2. Various HD-M units, Cage and ST (1.150- /1.151- /1.524-9xx.0)

Control piston pressure switch
(4.624-301.3 /-414.3 /-416.3)

Service Bulletin.

No. 2021-011 dated 08/02/2021

Fig. 1:

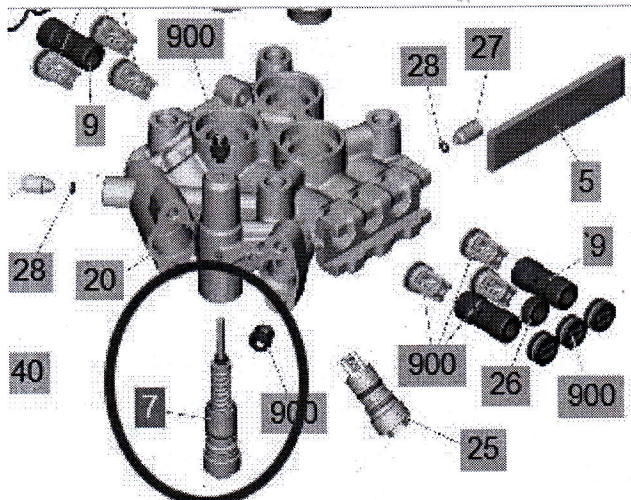
- Problem:** After closing the handgun, the unit switches OFF only after a delay or not at all.
- Cause:** The control piston pressure switch is available in different versions for various units in the HD Middle Class.
There may possibly also be air left in the pump.
- Solution:** If the unit switches OFF with a delay, it is advisable to install the reworked, standardised control piston pressure switch (4.580-104.3). Correct switching OFF of the unit is thus improved.
The control piston pressure switch was already introduced in **SB 2019-004, point 4.**
Venting the unit correctly is also important. See point 6 (unit ventilation) of this bulletin.
The new control piston pressure switches are reverse-compatible. They can be fitted in existing cylinder heads without any problems.

Pos. 7 Control piston
pressure switch new
4.580-104.3

**Fig. 1: Control piston old,
12 mm Ø , with cylinder lining**

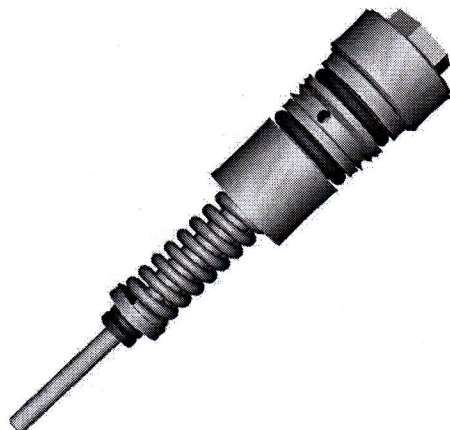
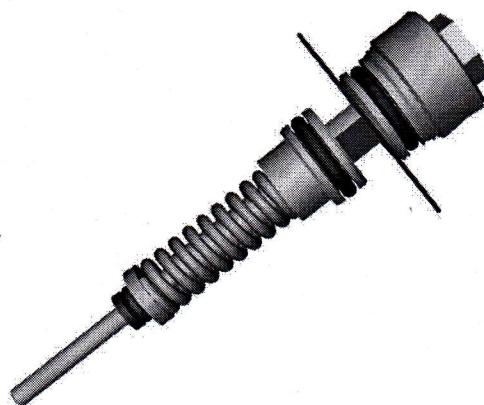
Units	Old control piston	New control piston
HD 6/15 M, HD 7/17 M (1.150-9xx.0 /1.151- 9xx.0)	4.624-301.3	4.580-104.3
HD 6/14 M, HD 7/14 M (1.524-9xx.0)	4.624-416.3	4.580-104.3
HD 7/16 M, HD 8/18 M (1.524-9xx.0)	4.624-414.3	4.580-104.3

**Fig. 2: Control piston new,
14 mm Ø, without cylinder lining,
two-part**
